## PLANNED UNIT DEVELOPMENT

& SUBDIVISION STAFF REPORT Date: February 7, 2008

SUBDIVISION NAME Montecito Subdivision

**CONTEMPLATED USE** Planned Unit Development Approval to allow 14 apartment buildings (366 units) and a clubhouse on a single building site and Subdivision approval to create three legal lots from a legal lot of record.

## SITE PLAN

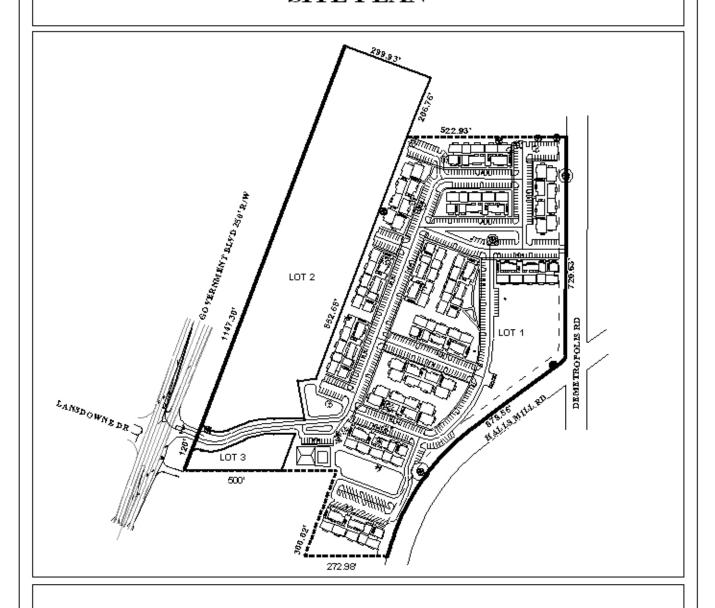
Driveway number, size, location, and design to be approved by Traffic Engineering and conform to AASHTO standards. Traffic impact study was received and reviewed. Access drive #1 must line up with Lansdowne Drive. Developer will install traffic signal on Government Boulevard at Lansdowne Drive and Site Access drive #1 as well any improvements to the intersection. The developer will also be responsible for the recommended intersection improvements at Halls Mill and Demetropolis. Detailed plans for improvements must be approved by Engineering and Traffic Engineering.

The applicant is proposing a 366 unit apartment complex with fourteen three-story apartment buildings, an outdoor pool with a clubhouse building, and a mail kiosk on approximately 17.2 acres. There is also a Future Development area of approximately 1.5 aces. A total of 592 surface parking spaces are provided, which slightly exceeds the 549 spaces that are required by the Zoning Ordinance.

Access to the proposed apartment development on Lot 1 will be via a driveway from Government Boulevard (U.S. Highway 90): an access point is also proposed to Demetropolis Road. The proposed driveway to Government Boulevard should provide access to Government Boulevard for Lot 3, due to its limited road frontage, which would require an additional PUD application. Proposed Lot 1 will have approximately 120 feet of frontage onto Government Boulevard, Lot 2 will have approximately 1,148 feet, and Lot 3 approximately 55 feet.

Access management is a concern due to the location of the proposed lots, the presence of a major street, the traffic volumes along the major street, the presence of an entrance/exit to another large subdivision across the street from the site, and the close proximity to the Knollwood Drive/Government Boulevard intersection. The location of the existing entrance/exit to Lansdowne Subdivision and the proposed location of the entrance/exit into the proposed apartment complex, and the out parcels generally, raises concerns of conflicts relating to turning movements. Furthermore, the volume of traffic generated by the apartment complex, the adjacent Lansdowne Subdivision, and the nearby Knollwood Drive/Government Boulevard intersection at this location is of great concern. As illustrated on the preliminary plat it seems that the apartment complex entrance and the entrance to the existing Lansdowne Subdivision may not require redesign/relocation; however, the Traffic Impact Study will determine if redesign or relocation would be necessary.

The applicant is proposing a "multi-family" PUD residential development, and consequently, PUD landscape area requirements apply. Section 64-5.C.2. of the Zoning Ordinance requires 700 square feet of open space per dwelling unit, which cannot include streets, drainageways, parking areas, service areas and land covered by buildings. Furthermore, compliance with the tree and landscaping requirements of the Zoning Ordinance will be required due to the proposed B-3 zoning of the site. Information on the site plan indicates that adequate area will be available for compliance with the landscaping requirements of the Zoning Ordinance. Additional information regarding compliance with the tree requirements must be submitted with the request for permits to develop the site.

- 1. access drive #1 must line up with Lansdowne Drive;
- 2. developer will install traffic signal on Government Boulevard at Lansdowne Drive and Site Access drive #1 as well any improvements to the intersection;
- 3. the developer will also be responsible for the recommended intersection improvements at Halls Mill and Demetropolis; and
- 4. detailed plans for improvements must be approved by Urban Development, Engineering and Traffic Engineering.

- 1. access drive #1 must line up with Lansdowne Drive;
- 2. developer will install traffic signal on Government Boulevard at Lansdowne Drive and Site Access drive #1 as well any improvements to the intersection;
- 3. the developer will also be responsible for the recommended intersection improvements at Halls Mill and Demetropolis; and
- 4. detailed plans for improvements must be approved by Urban Development, Engineering and Traffic Engineering.
